**MONTROSE
PLANNING AND ZONING COMMISSION MEETING
AGENDA**

A. To Consider a Request for a Preliminary Plat for Creekside Hollow, an 80-lot Single Family Development on Approximately 40 Acres of Land Zoned R-1, Single Family Residential

Creekside Hollow Preliminary Plat

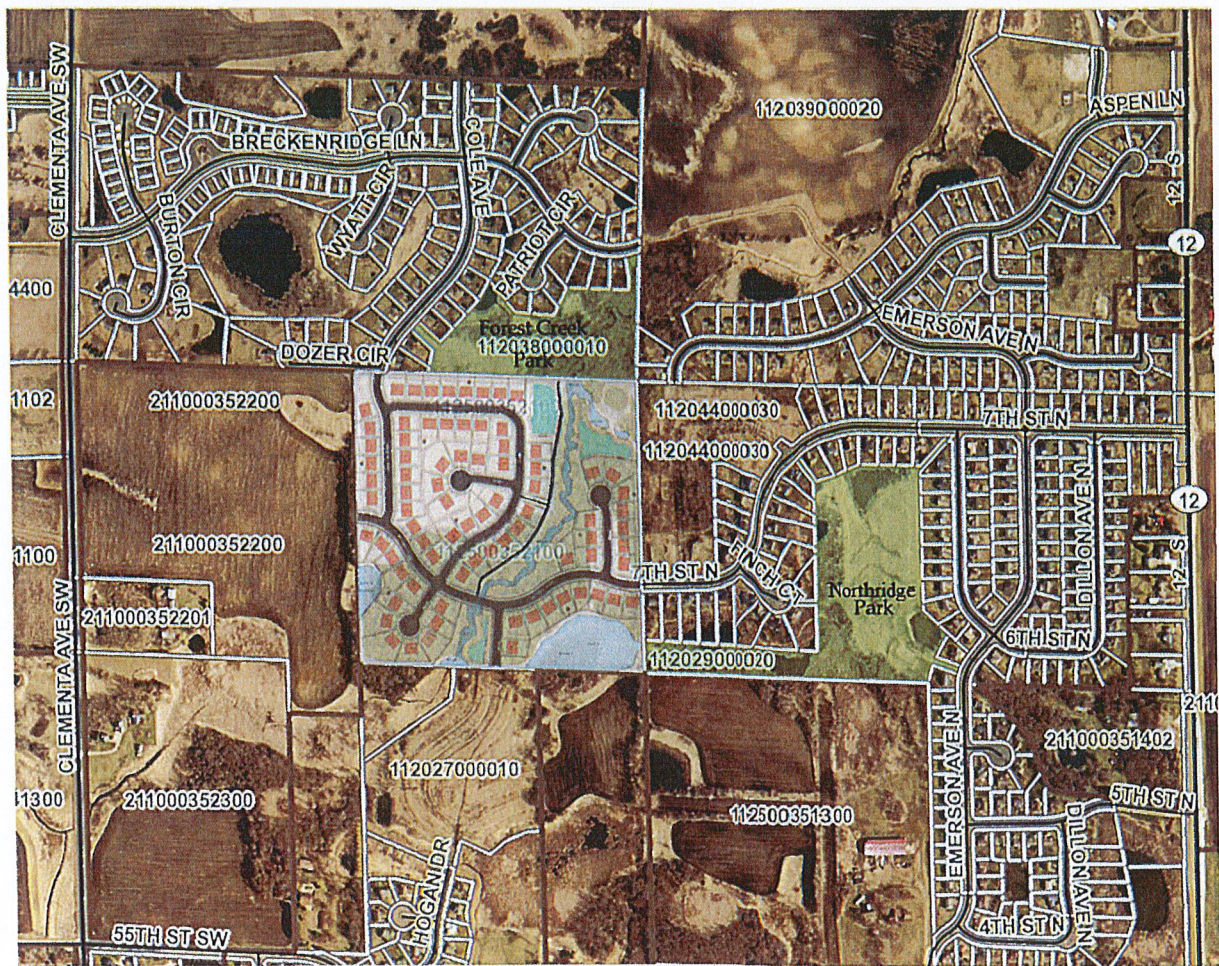
Planning staff disagrees with this assessment. Without that connection – and in a very early phase of development - it is arguable that none of this subdivision is buildable due to the additional traffic burden it would place on already over-burdened external local streets. The city has treated this east-west connection as a “minor collector” street, which is one that is designed to carry a bit more than the standard traffic of a residential neighborhood, but which is still permitted to have direct driveway and lot access. Major collectors, by contrast, would not typically have direct lot access.

The overall street arrangement proposed is an acceptable design for the subject property, and should result in an attractive subdivision with conforming single-family lots. However, street connections and construction would appear to raise a significant issue with project timing. Staff would recommend that the connection to 7th Street to the east is a vital connection to make as an initial aspect of the project development.

Moreover, that connection is necessary to make the overall project feasible rather than a connection that benefits off-site property. If practical, planning staff would recommend that Phase 3 be the first phase of this project, including a connection across the creek to be timed with Phase 2 construction to the west. If not due to utility service concerns, some connection of the streets between Forest Creek to the north, and Park View to the east should be required as a part of first phase construction. Efforts to minimize the design needs or cost of the creek crossing would be supported, pending City Engineer approval, but these costs are attributable to this project.

- **Larger Sized Trees Installed:** The landscape Plan utilizes 2.5" (minimum) sized replacement trees. The trees have been located on the site in an acceptable manner, however, larger than minimum sizes could be proposed to raise the caliper inches to meet the required removal threshold.
- **Grading Limits:** It would appear that the limits of grading could be altered in several locations to preserve significant trees—particularly in rear lots. Lessening rear yard "flat" area size, utilizing walls, or utilizing steeper slopes would save more of the existing tree cover—resulting in a lower tree removal over the 50% allowed.

In this review—500" inches of trees to be removed were identified that were within the 50' OHWL creek setback (Wetland C). Keeping grading out of the creek wetland buffer would reduce the tree loss by this amount.

- **Stormwater Pond (Basin 200P):** A large number of significant trees have been removed for the location/construction of basin 200P—while the area in the NE corner of the site appears to have a limited number of significant trees, yet a comparable area in size. If possible, shifting the pond to the north would reduce tree loss. As noted below, this area is of marginal use for park land.

1. The phasing plan shall be revised to include the creek crossing and connection to 7th Street North as an early part of the development phasing instead of the last phase as currently proposed.

21. The creek running through the site is located in the Shoreland Overlay District. The structure setback requirement is 50-ft from the ordinary high-water level. According to the site plan, several lots do not meet this criterion. The layout shall be adjusted accordingly.

1. The applicant considers modified grading as noted in this report, reducing tree loss and minimizing replacement requirements.
2. The applicant provides additional replacement tree planting not possible in the proposed plat in accordance with the Subdivision Ordinance noted above, including either or both tree planting in eligible off-site locations and/or cash payments according to city policy and ordinances.

3. The plat layout and phasing to be timed to ensure that street connections from the north through to the east are made as part of the initial phasing to avoid further overburdening of the street traffic in adjoining neighborhoods.
